Bryce Canyon

Hardware Specification update

OCP Specification Updates list

Figure 13 - Hard Drive Serial Number Window

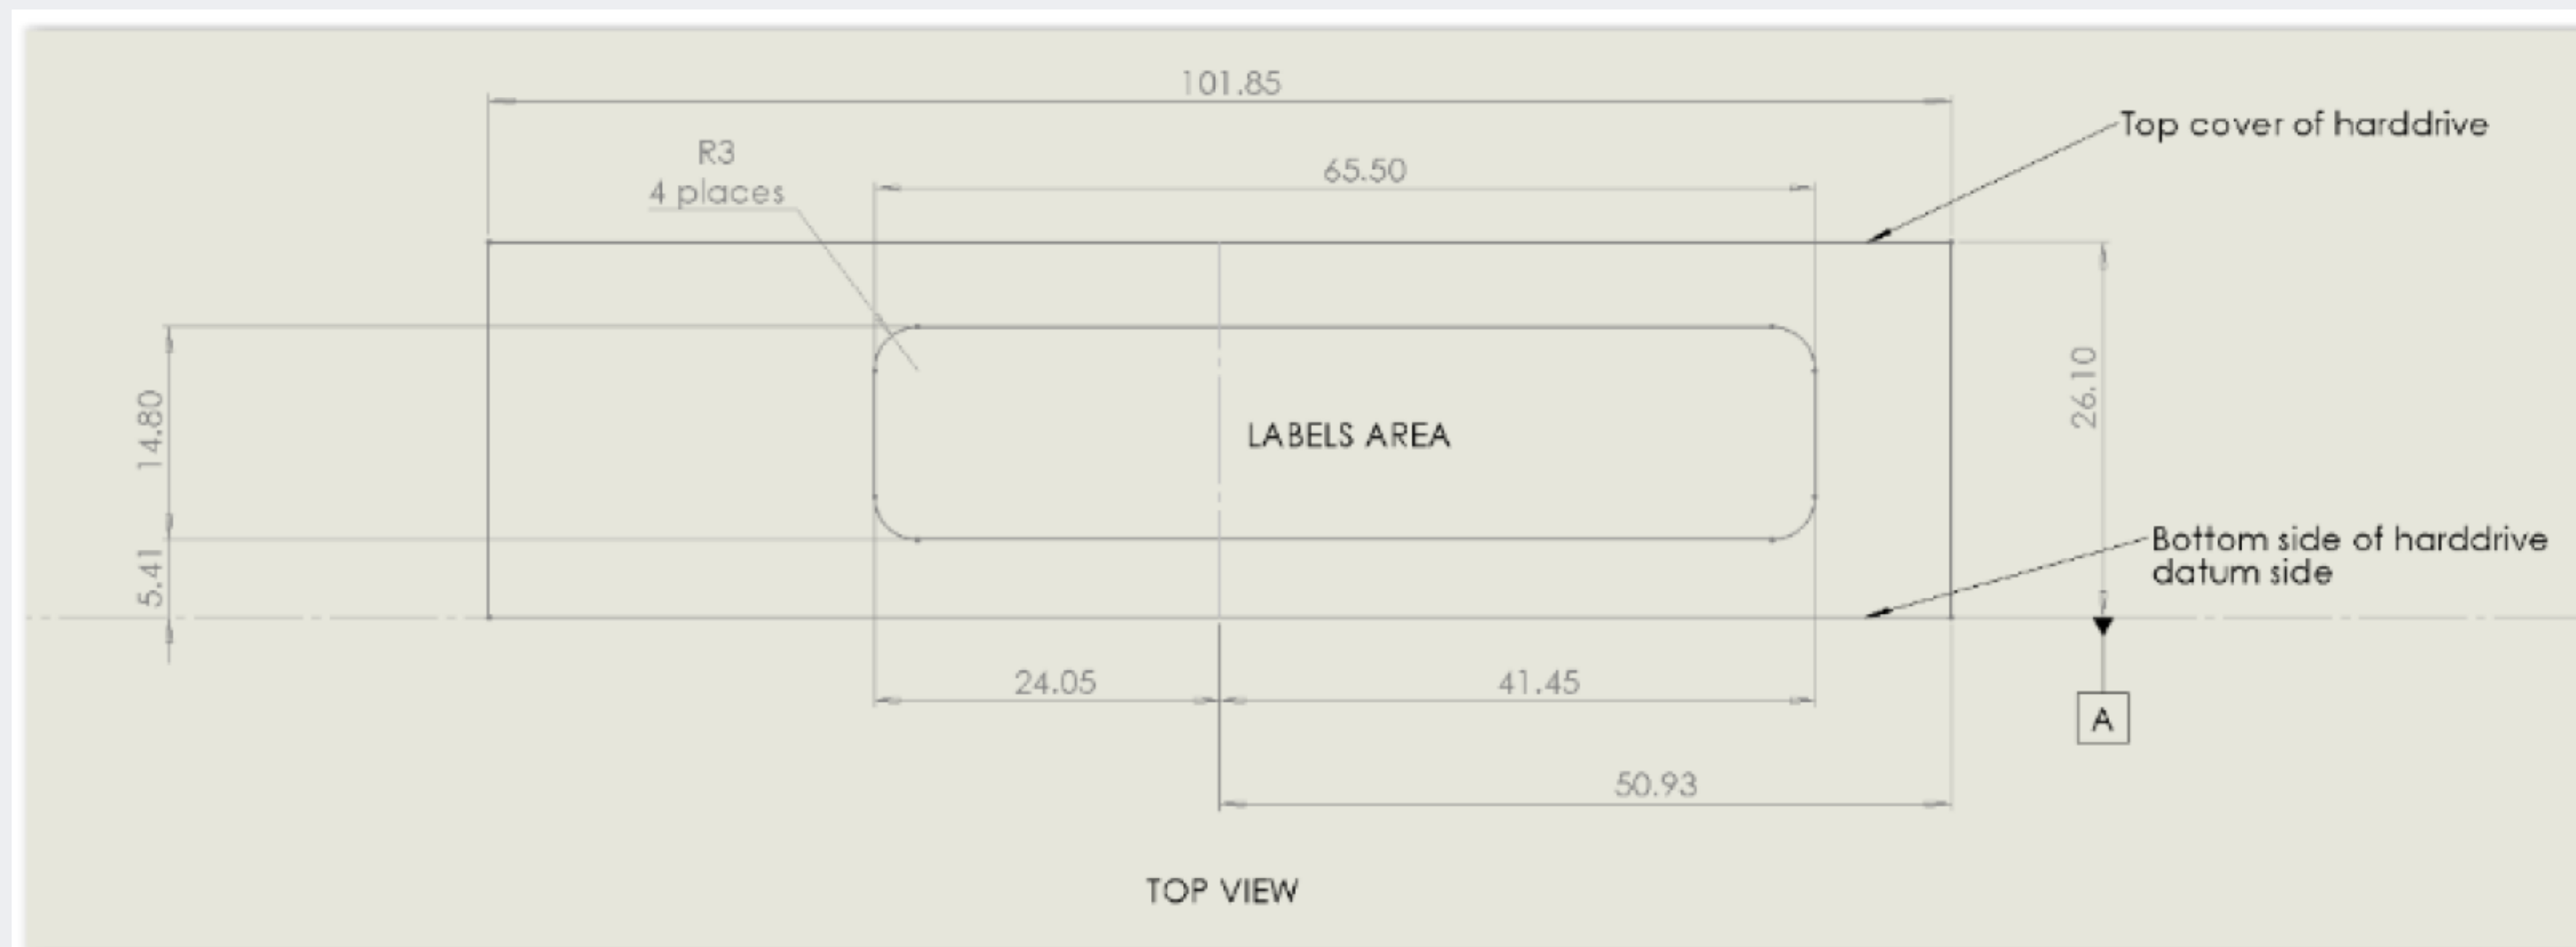
- All CAD renderings were updated with the latest images
- Added details for the window on the HDD latch to enable scanning of HDD serial number.

Figure 101: Mylar on IOM tray and HDD latch to improve service time

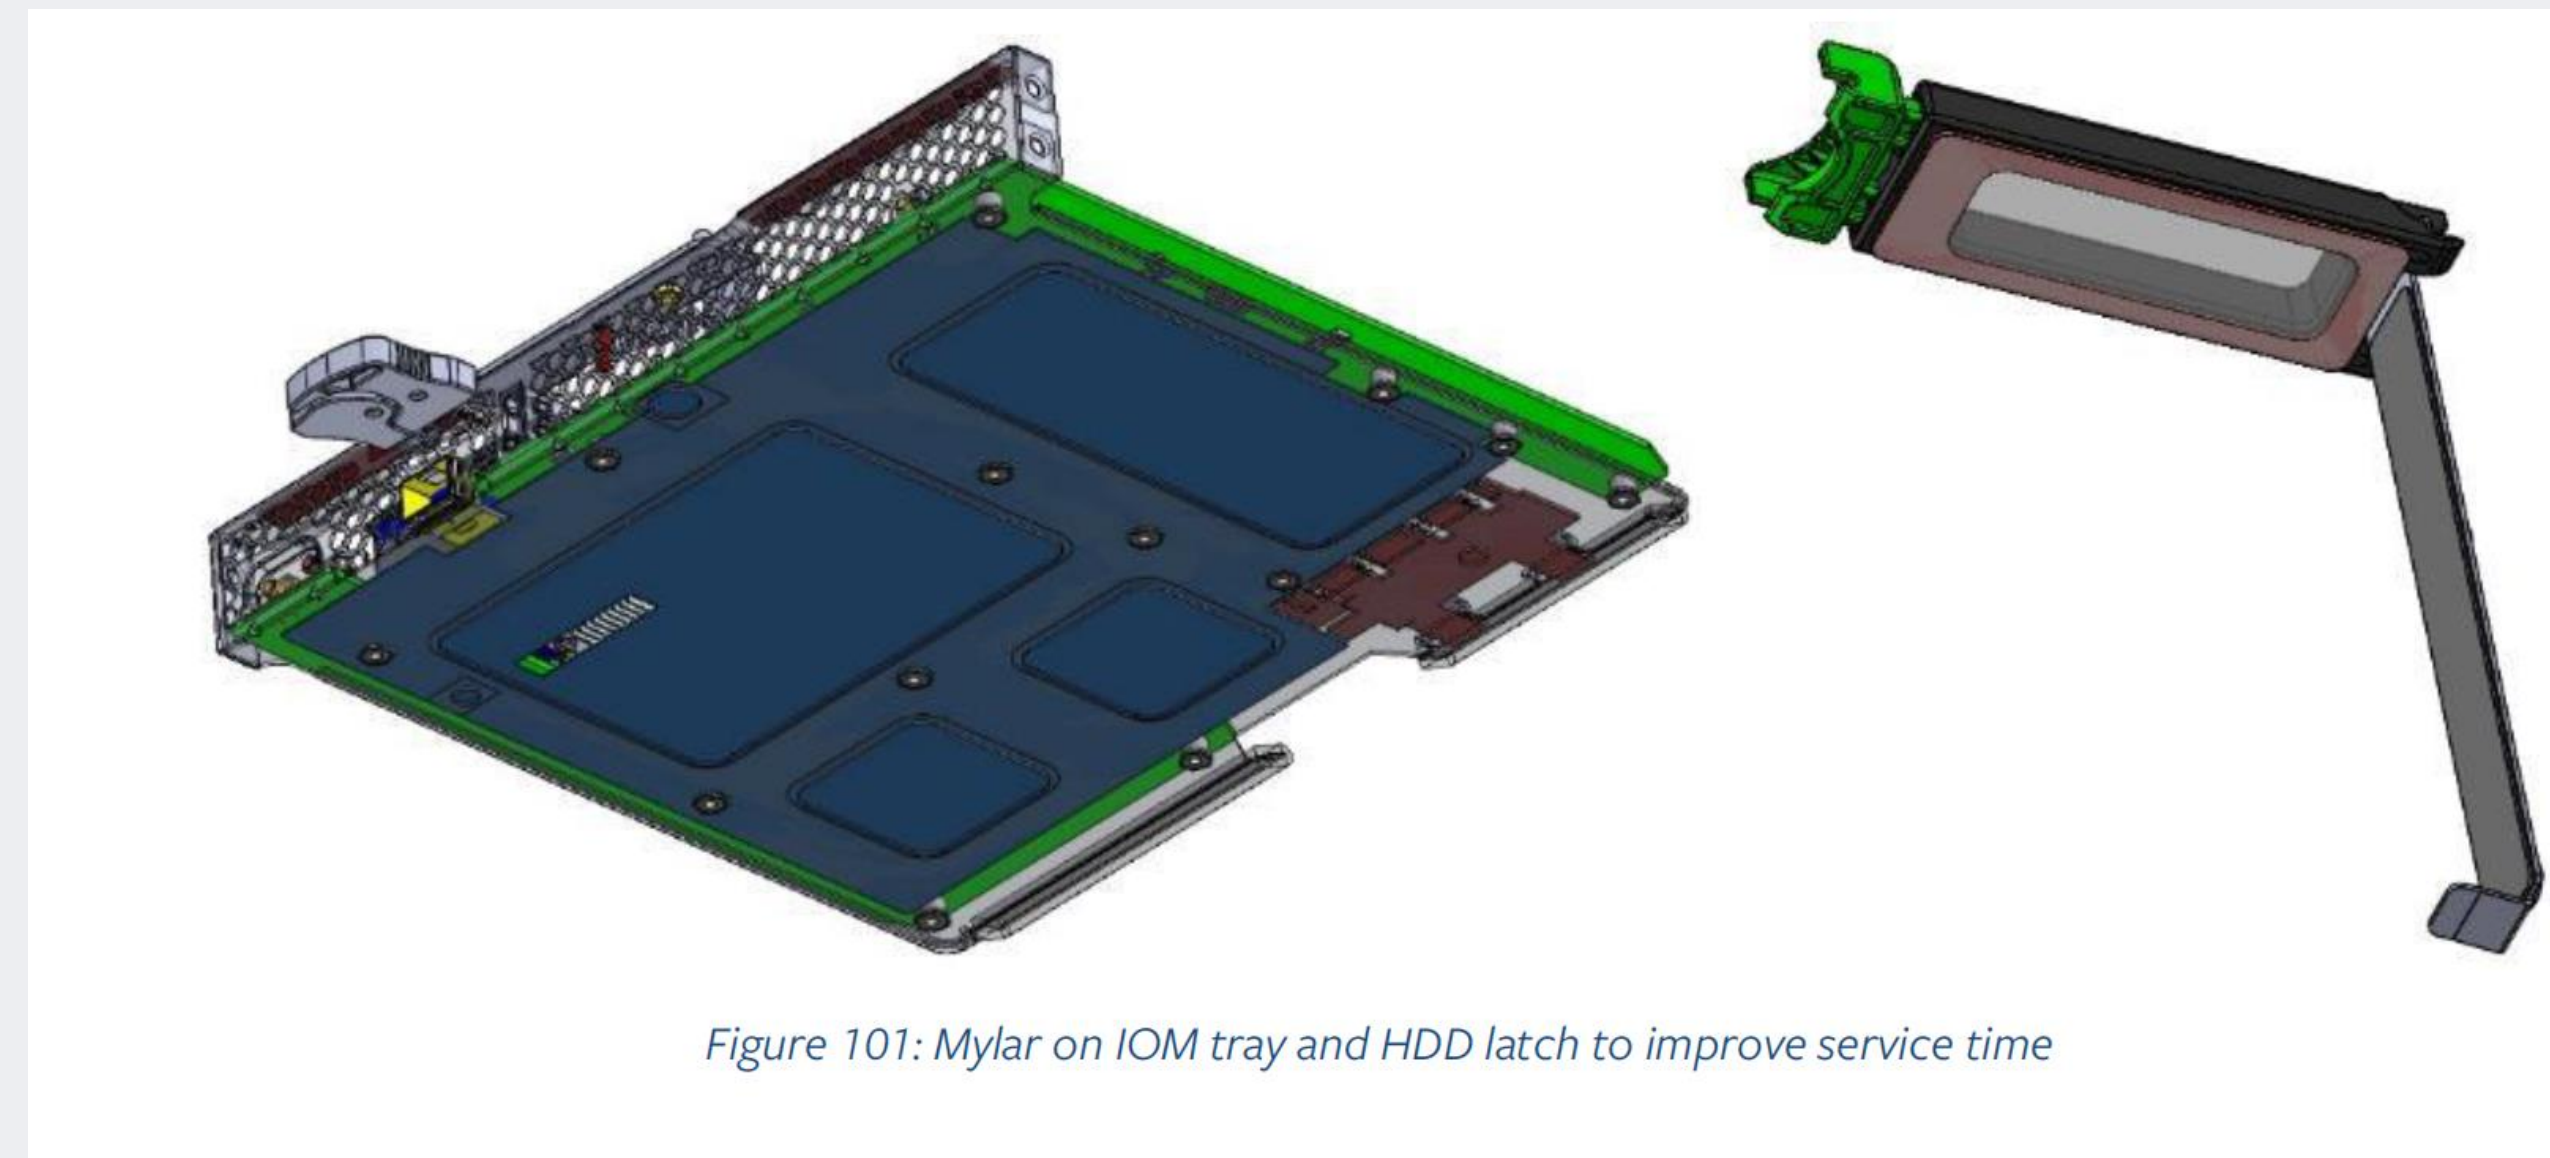
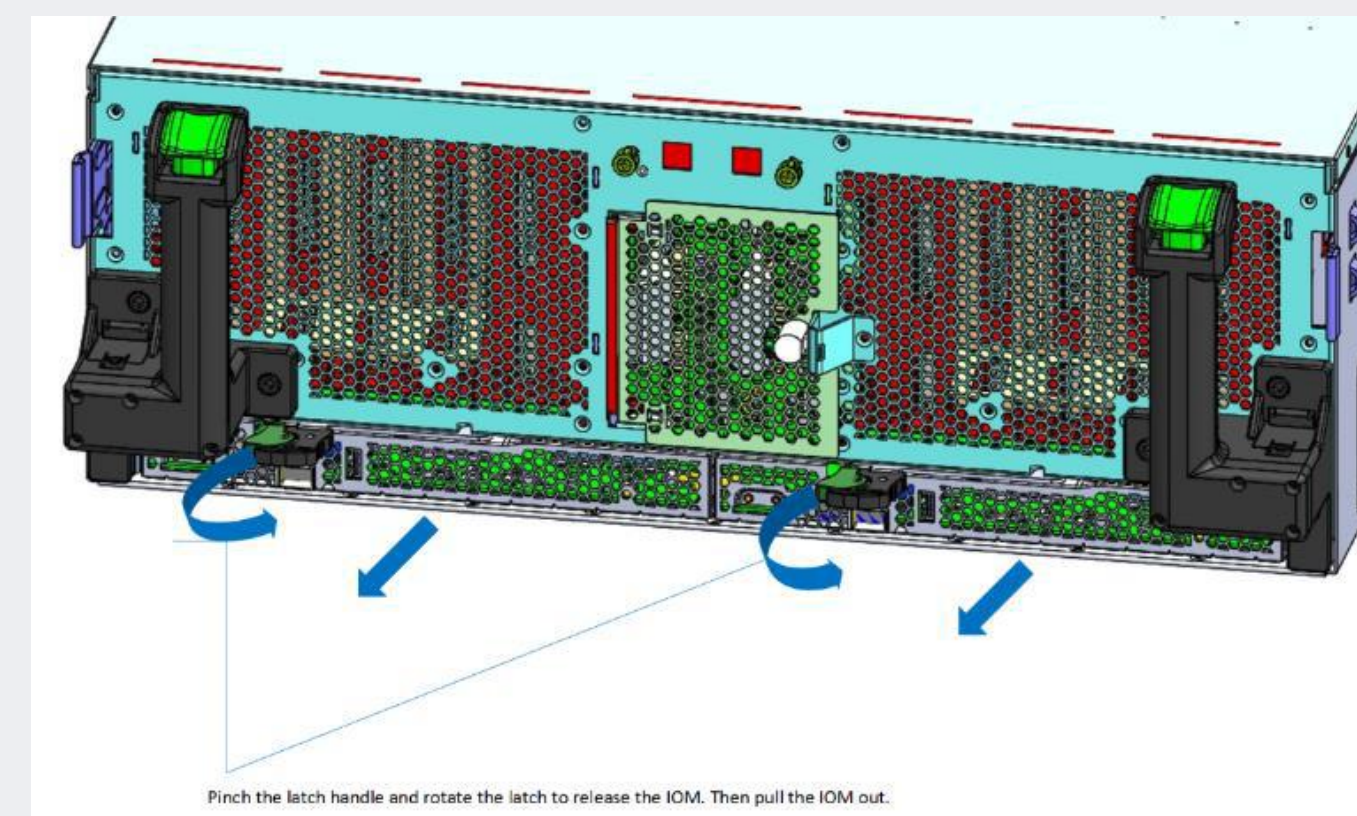
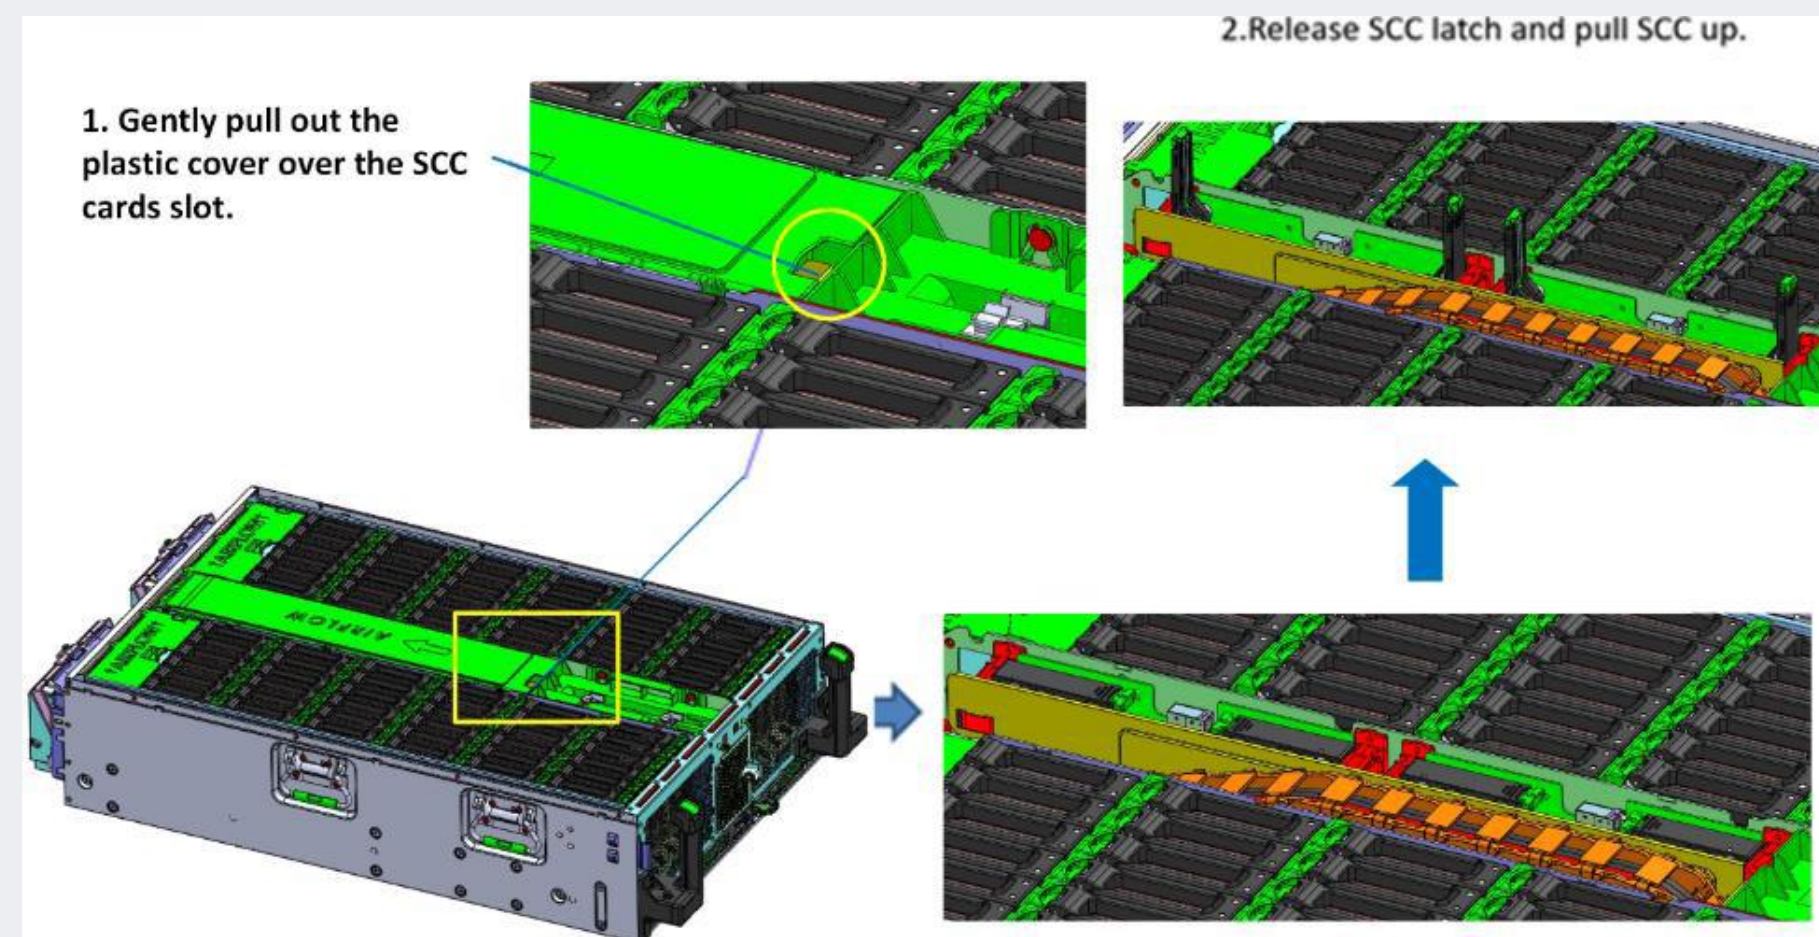
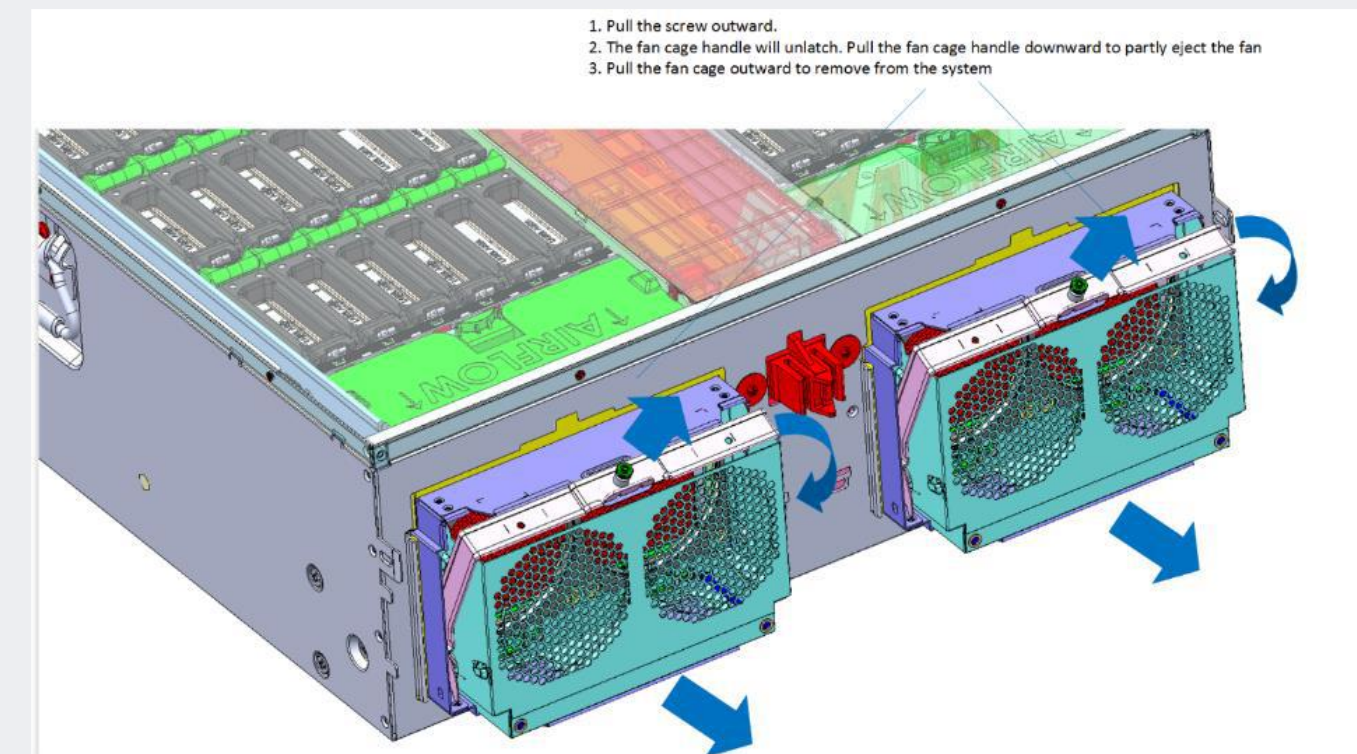
- Updated Thermal section
 - Final Bryce Canyon fan speed curves
 - Final fan cage and latch design
 - Mylar added under the IOM and transparent mylar added under HDD drive retention latch to improve online service time to >20mins when the drawer is pulled out all the way.
- Updated Mechanical section with the final implementation and CAD renderings of all chassis latches including PCBA and other FRU latches.
 - Drawer Sliding rail
 - Drawer release handles
 - Rack release latches
 - Rack lift latch
 - Drive Retention latch
 - IO Module card latch
 - Storage Controller card latch
